SUBJECT: DRESDEN - ISSUANCE OF AMENDMENTS - REVISED PRESSURE-
TEMPERATURE LIMITS (TAC NOS. MA8346 AND MA8347)

Amendment No. 179
License No. DPR-19

Amendment No. 174
License No. DPR-25

SAFETY EVALUATION BY THE OFFICE OF NUCLEAR REACTOR REGULATION
RELATED TO AMENDMENT NO. 179 TO FACILITY OPERATING LICENSE NO. DPR-19
AND AMENDMENT NO. 174 TO FACILITY OPERATING LICENSE NO. DPR-25
COMMONWEALTH EDISON COMPANY
DRESDEN NUCLEAR POWER STATION, UNITS 2 AND 3
DOCKET NOS. 50-237 AND 50-249

FIGURE 3.6.K-1

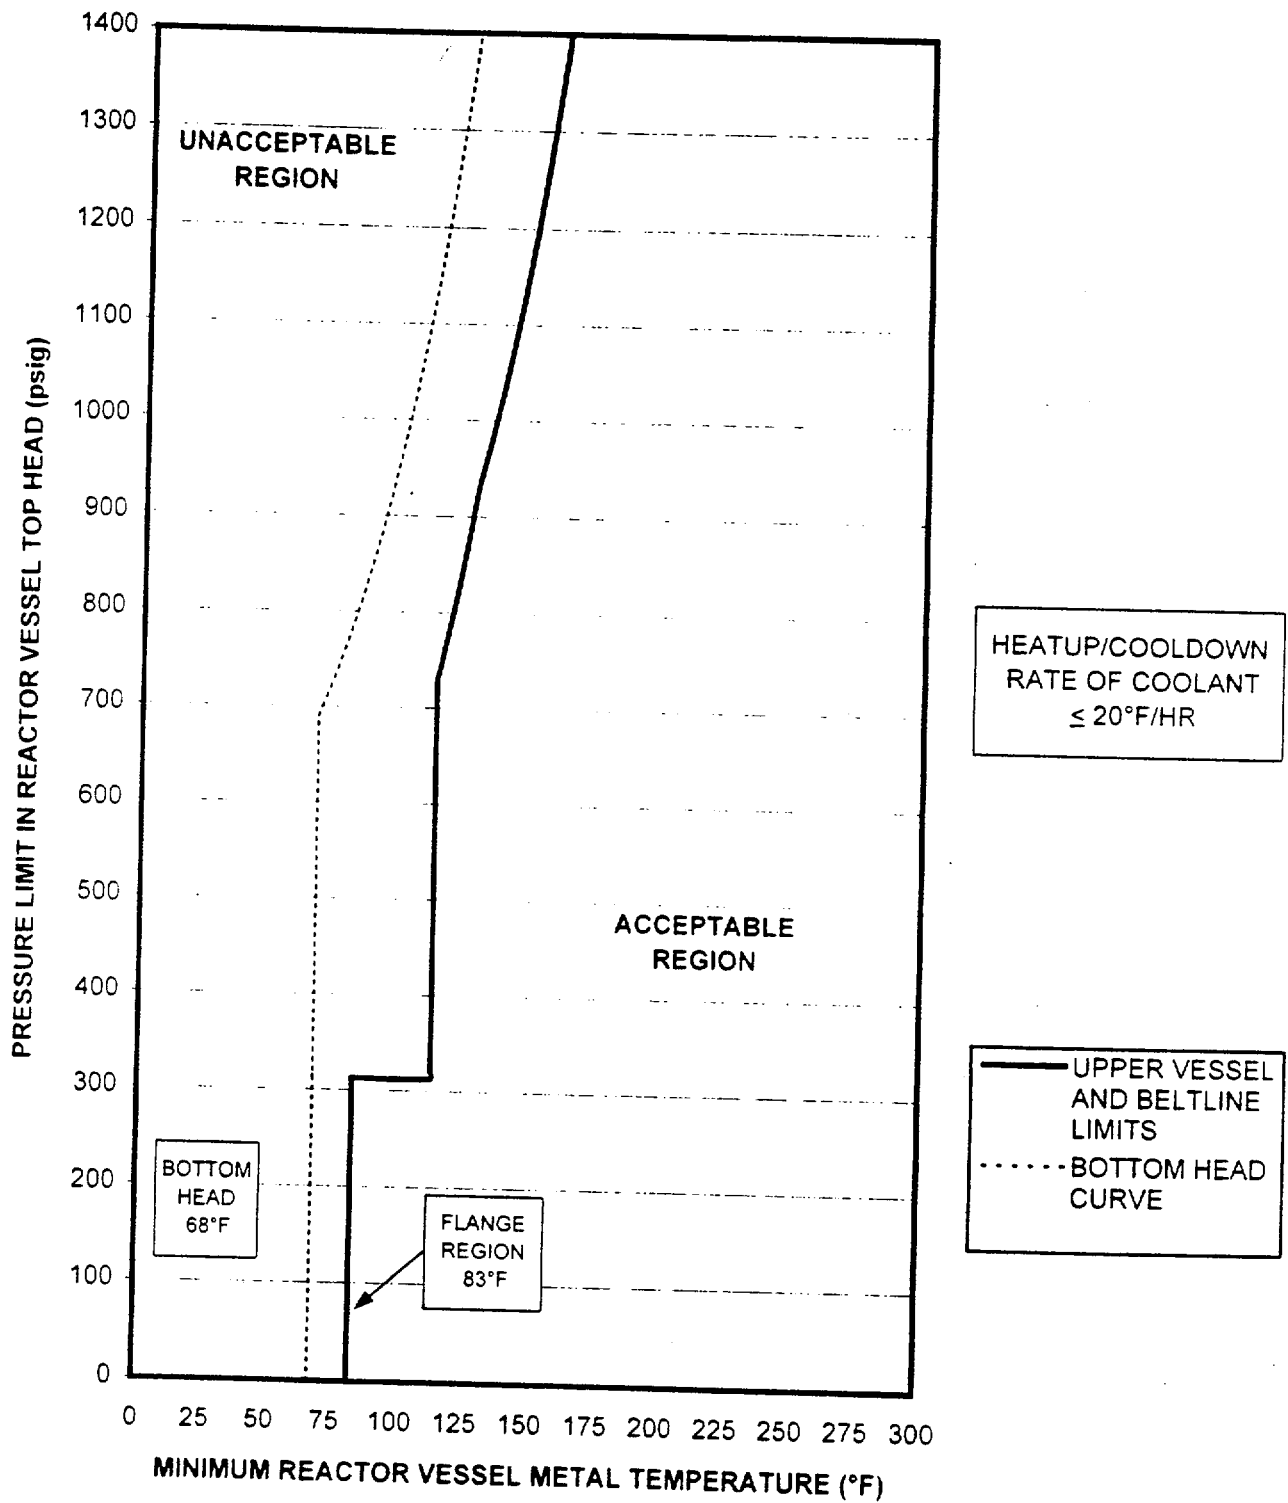
As indicated in Figure 3.6.K-1 for pressure testing, the minimum metal temperature of the reactor vessel shell is 83°F for reactor pressure less than 312 psig. This 83°F minimum boltup temperature is based on a RT_{NDT} of 23°F for the electrosag weld immediately below the vessel flange and a 60°F conservatism required by the original ASME Code of construction. The bottom head region limit is established as 68°F, based on moderator temperature assumptions for shutdown margin analyses. At reactor pressures greater than 312 psig, the minimum vessel metal temperature is established as 113°F. The 113°F minimum temperature is based on a closure flange region RT_{NDT} of 23°F and a 90°F conservatism required by 10 CFR Part 50 Appendix G. Beltline curves as a function of vessel exposure for 32 effective full power years (EFPY) are presented.

Figure 3.6.K-1 is governing for applicable pressure testing with a maximum heatup/cool-down rate of 20°F/hour.

FIGURE 3.6.K-2

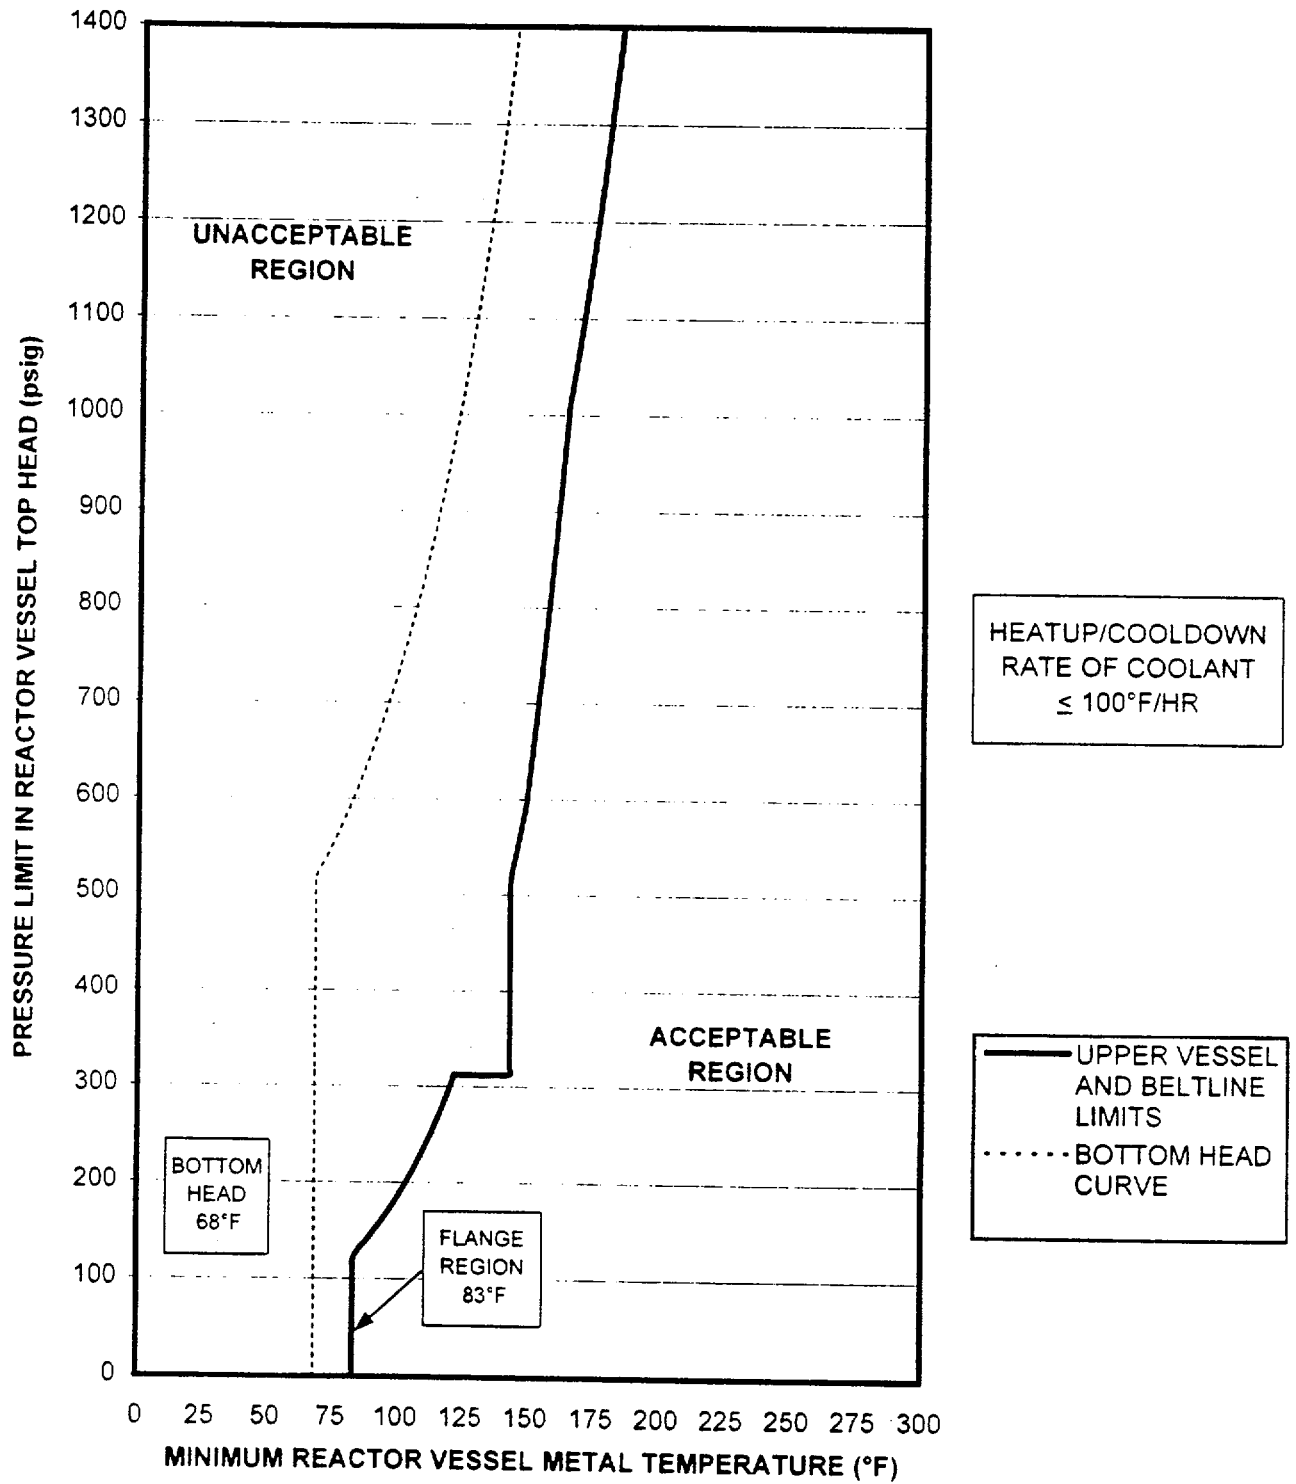
Figure 3.6.K-2 applies during heatups with non-nuclear heat (e.g., recirculation pump heat) and during cool-downs when the reactor is not critical (e.g., following a scram). The curve provides the minimum reactor vessel metal temperatures based on the most limiting vessel stress. The maximum heatup/cool-down rate of 100°F/hour is applicable.

FIGURE 3.6.K-3

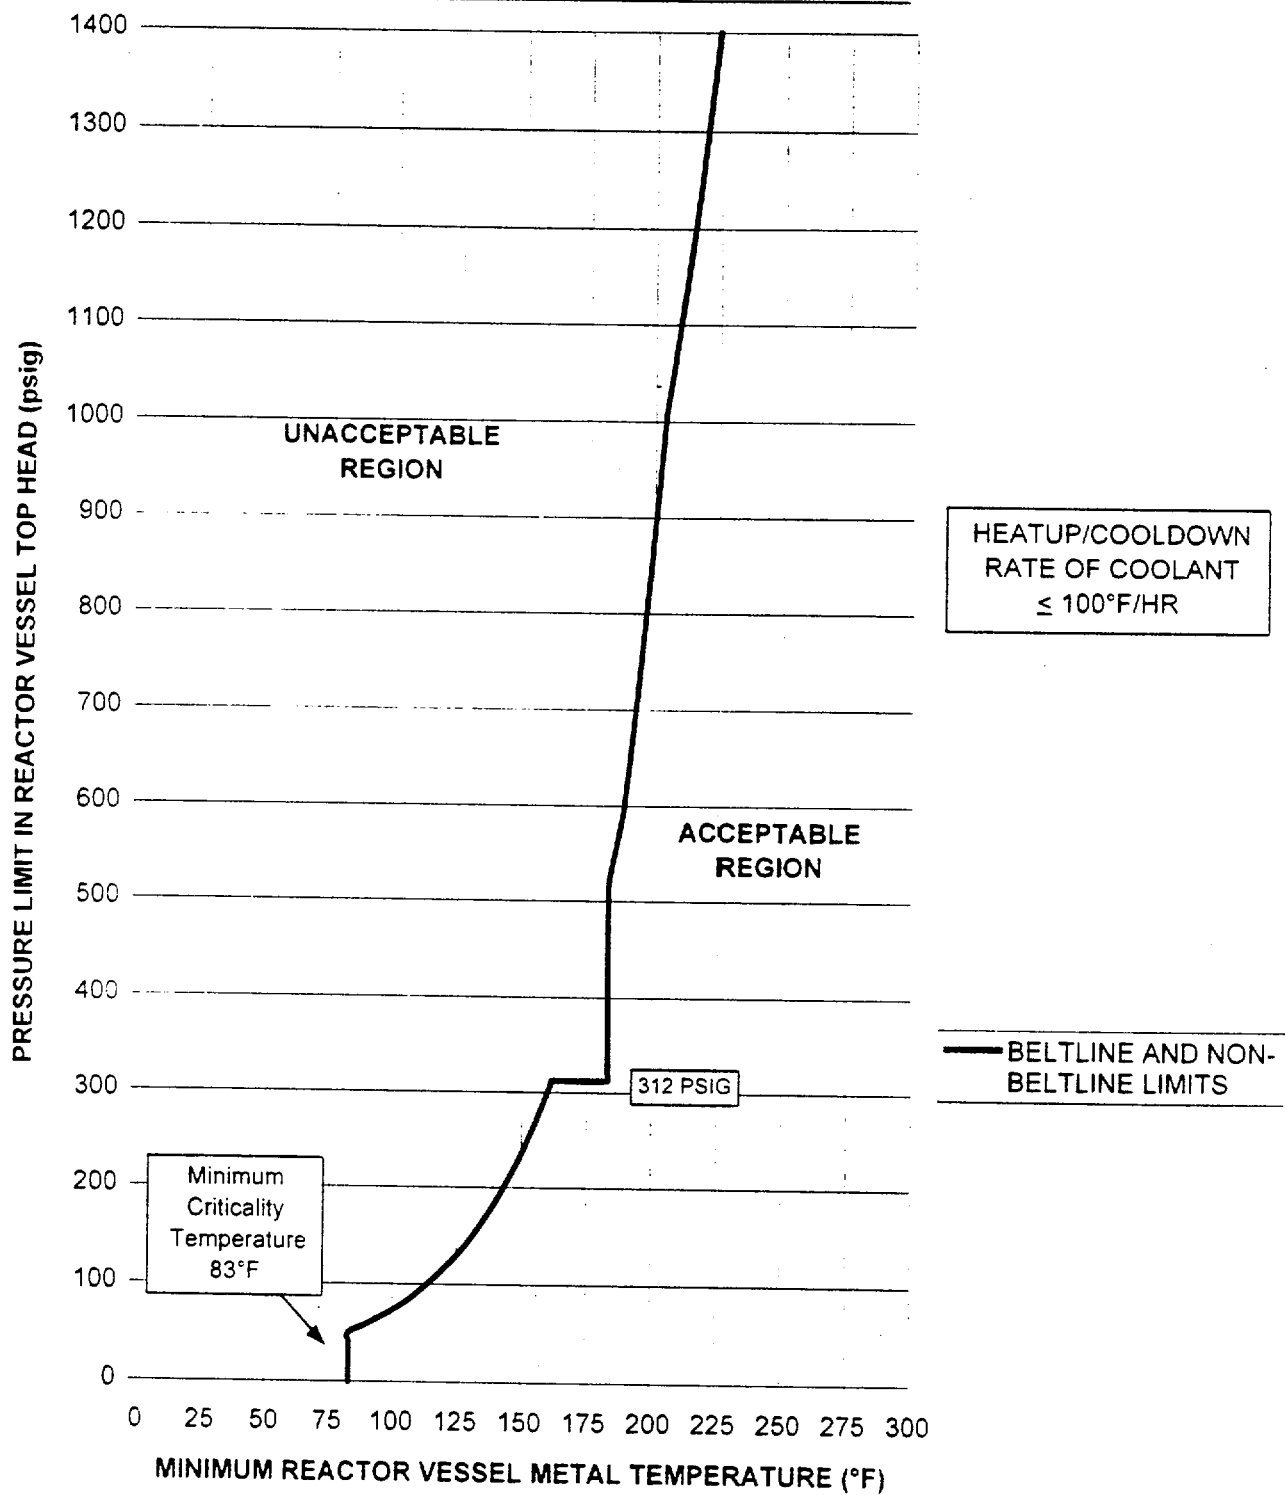
The core critical operation curve shown in Figure 3.6.K-3, is generated in accordance with 10CFR Part 50 Appendix G which requires core critical pressure-temperature limits to be 40°F above any pressure testing or non-nuclear heatup/cool-down limits.
